# Access Compliance Report

## Public Rights-of-Way

### (Pedestrian Signals)

Intersection ID: N/A	Main Street:	Cross Street: N/A	Location: N/A
ADA ID: 100F52BF5A8D	Signal Type: One Push Button-Non APS	Overall Compliance: No	Severity Score: BTN 1: N/A BTN 2: N/A No BTN: N/A
Codes/Mitigation Info/Possible Solution		Field Measurements/Component Compliance

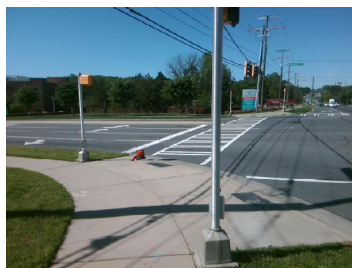
PROW/ADA: TMUTCD 4e.08, R404.2, R404.3, R406.2

Possible Solutions: Replace Signal Push Button With APS Button on New Post. Remove & Relocate Sign.
